Manitoba Hydro

Pointe du Bois Spillway Replacement

Alteration

August 2012

Figure:
3.24
Rev 1

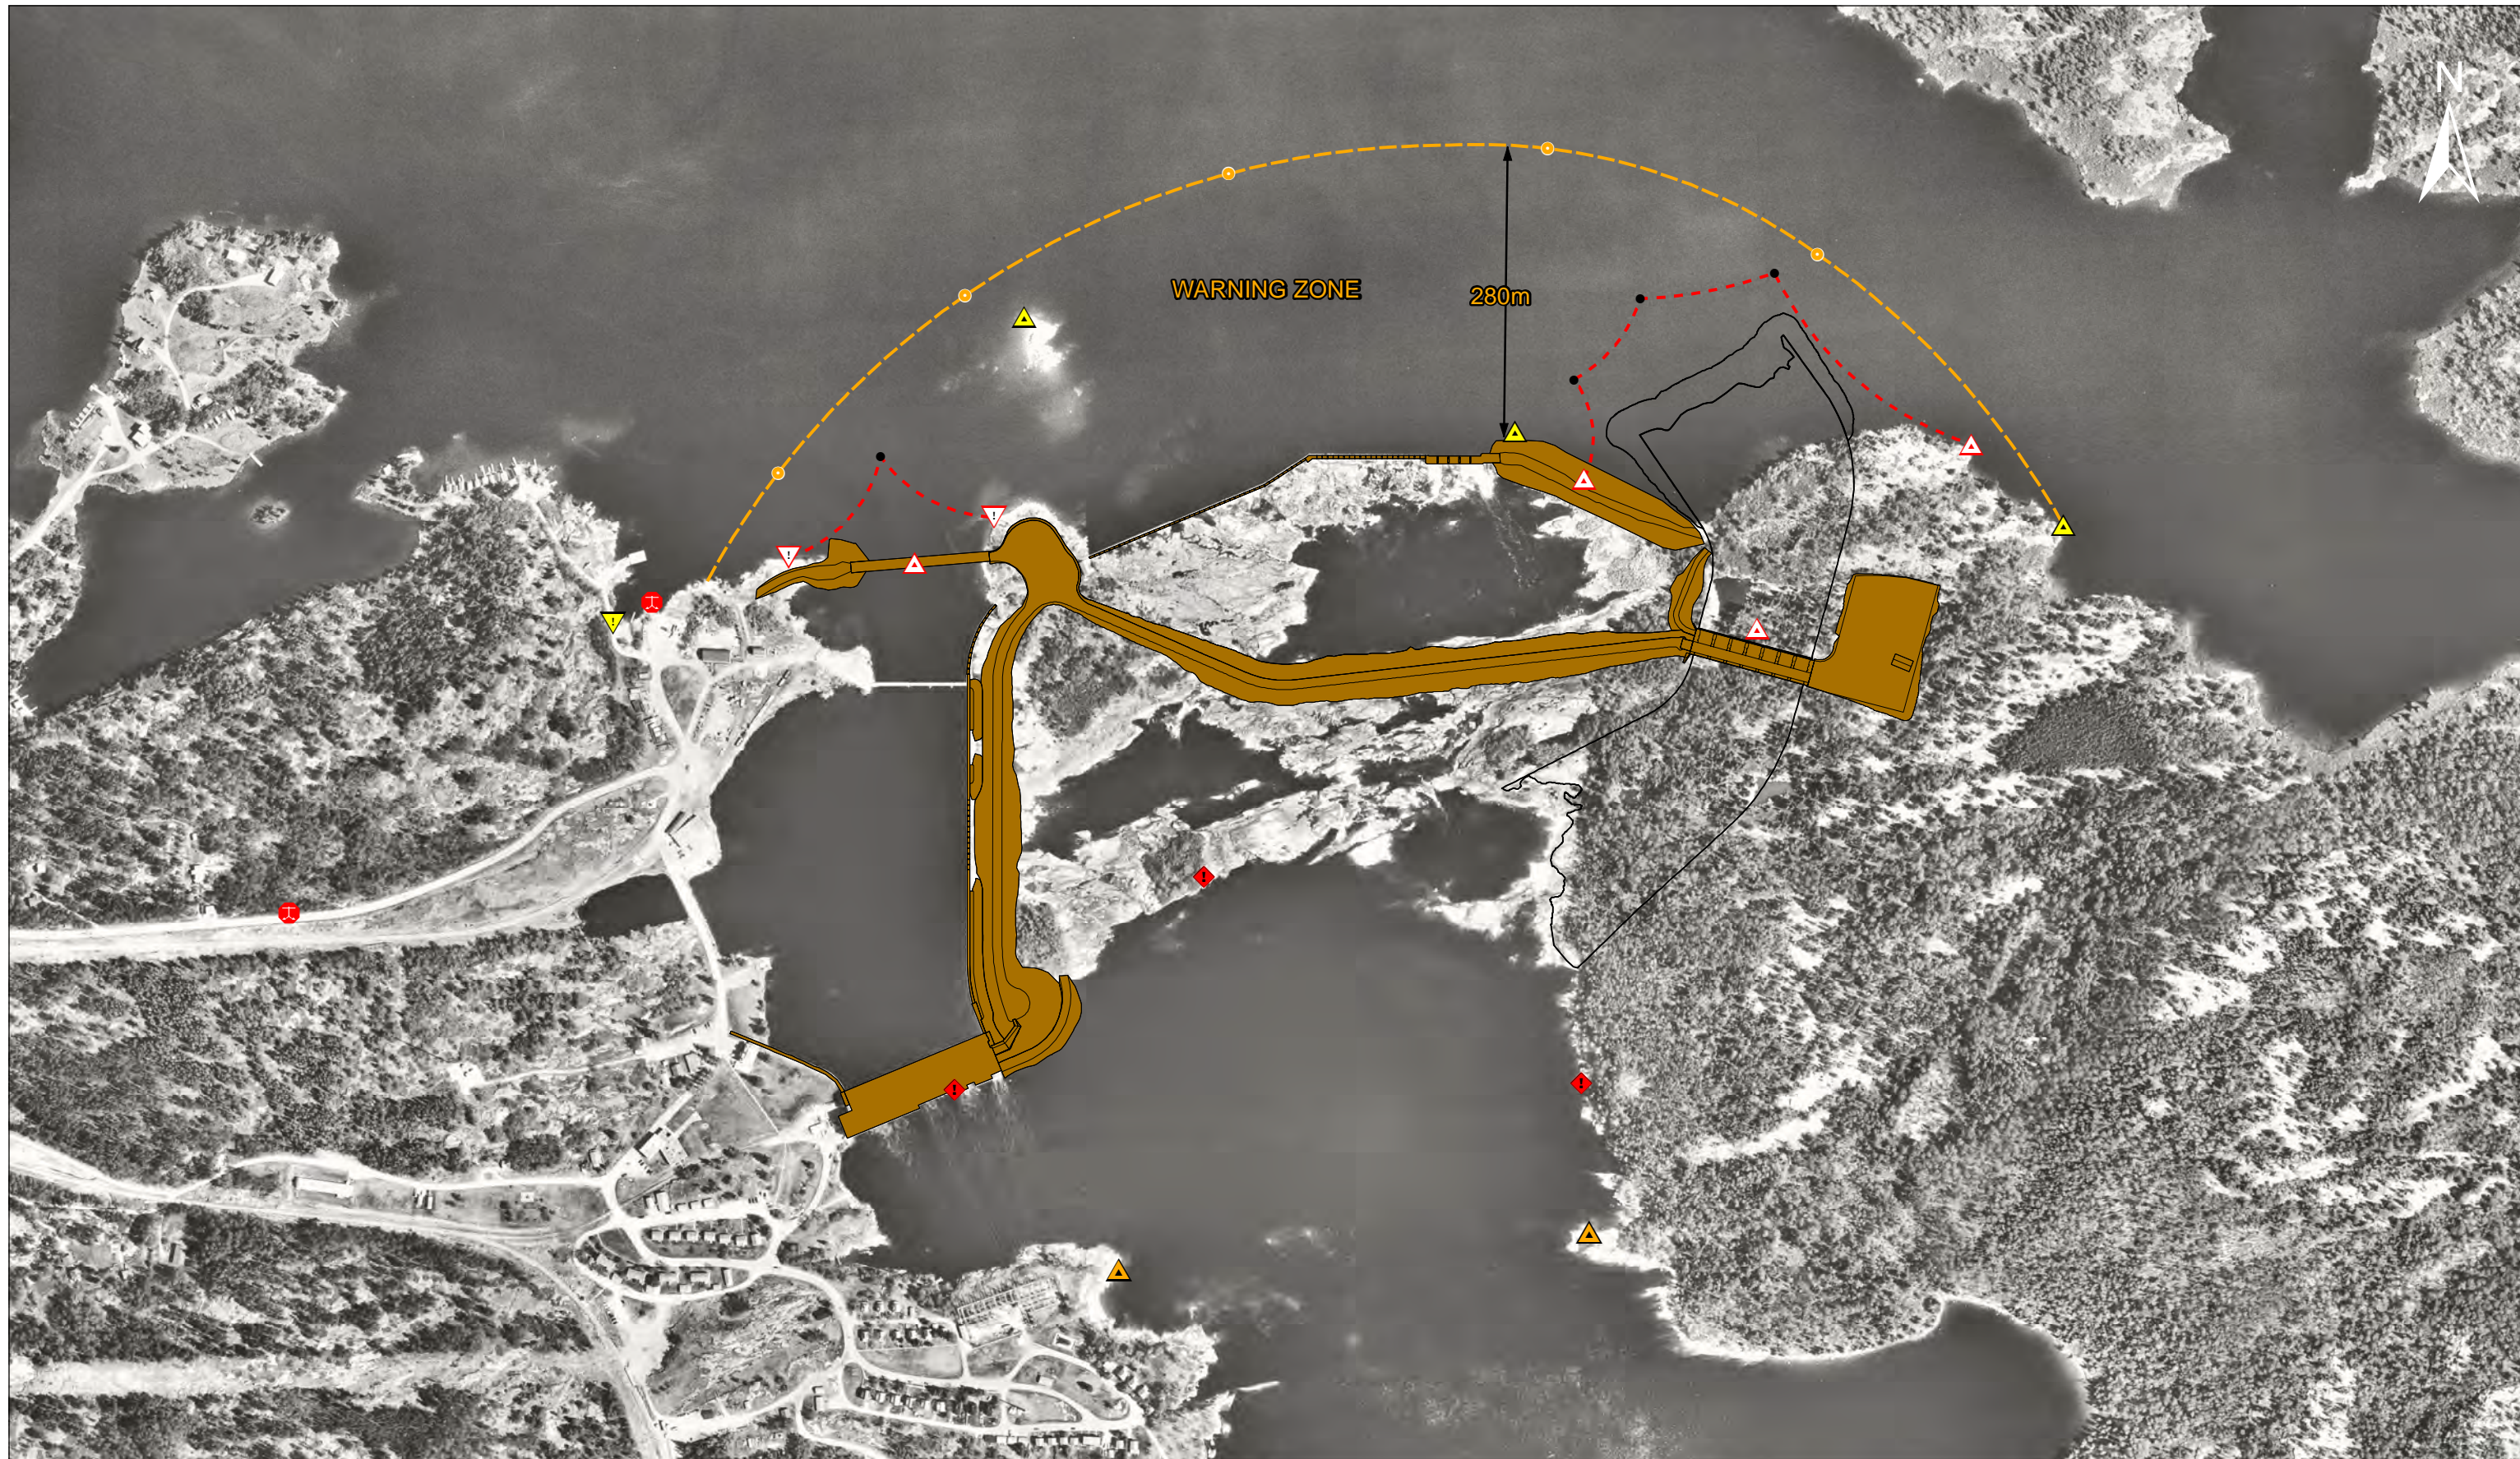
The earthfill dams will be zoned earthfill embankments, each consisting of an impervious core with granular and crushed rock filters and outer rockfill shells (Figure 3.24 Rev1).

Figure:
8.2B
Rev 1

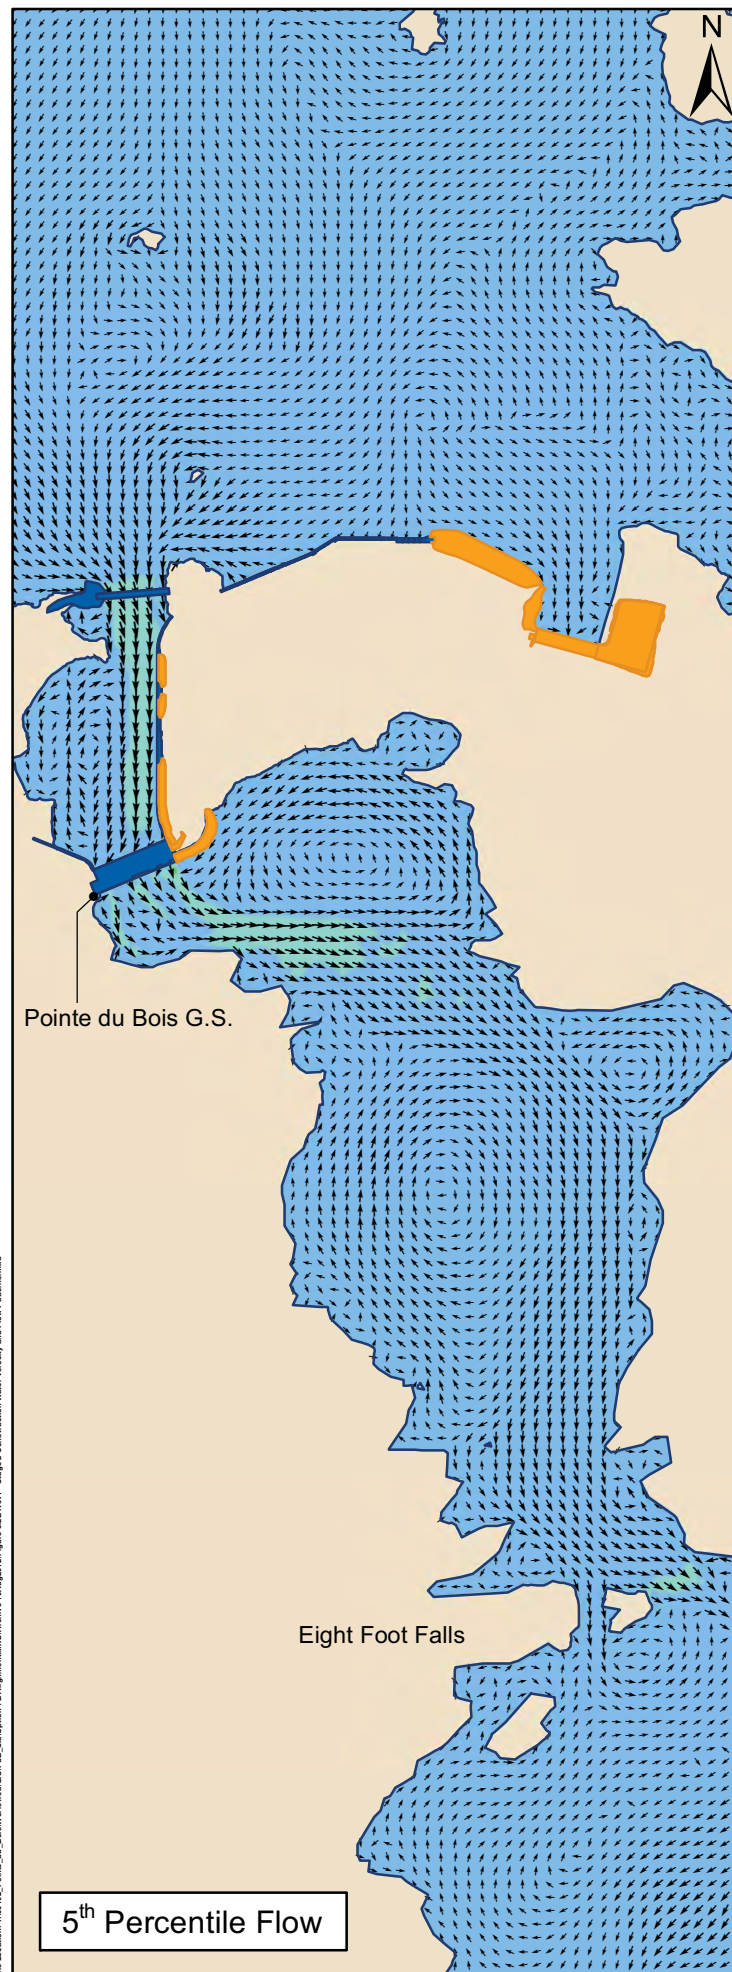
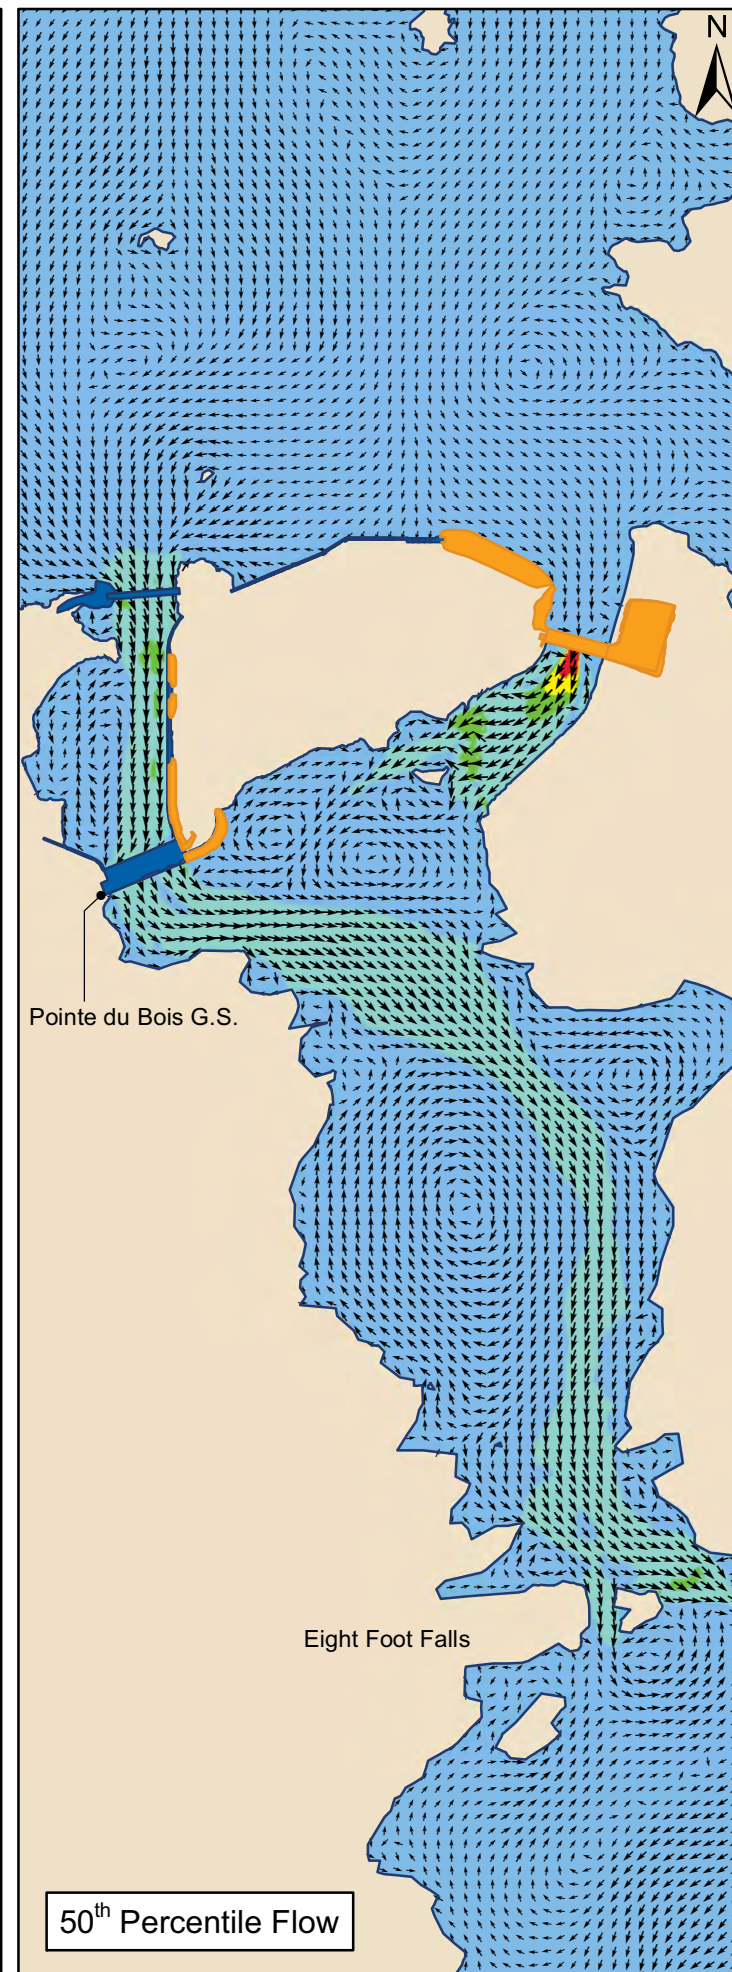
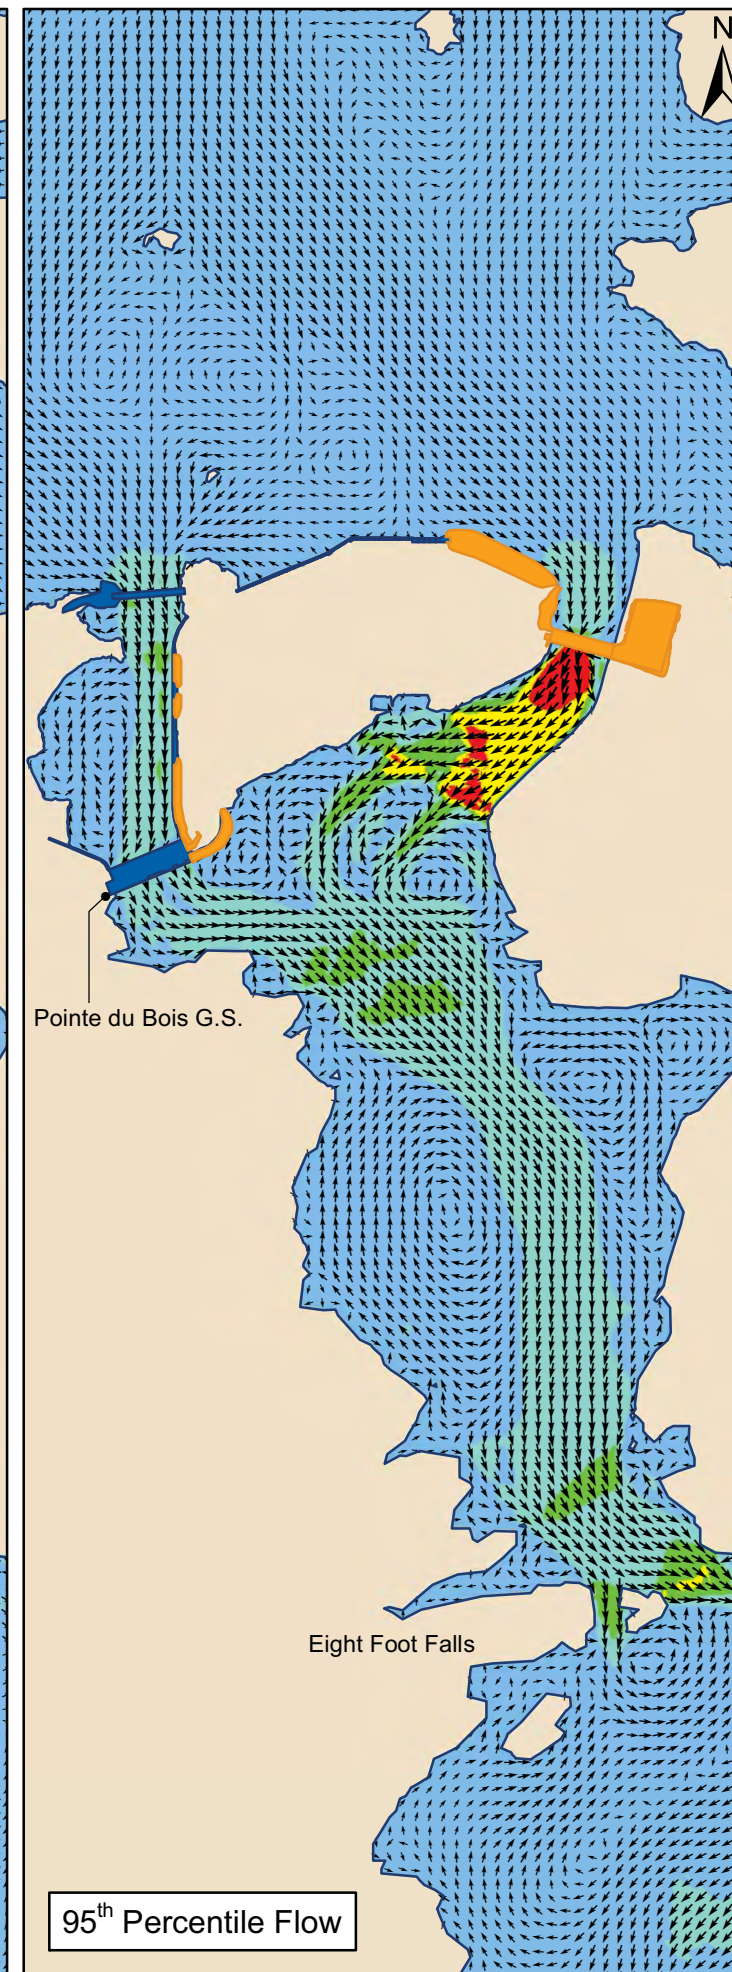
Tailrace changes are dependent on the magnitude of spill. The Revised Arrangement will result in similar changes to water velocities immediately downstream of the spillway rapids but with slight differences due to a shifted spillway discharge channel orientation as compared to the Original Arrangement. Refer to Figures 8.3A Rev 1 and 8.3Ai. Beyond 500 m downstream of the spillway discharge channel, there is no notable change in flow patterns or velocity with the Revised Arrangement as compared to the Original Arrangement. Depending on the magnitude of spill, the active flow zone either remains in the centre of the river or is pushed towards the east bank (Figure 8.2 B Rev1).
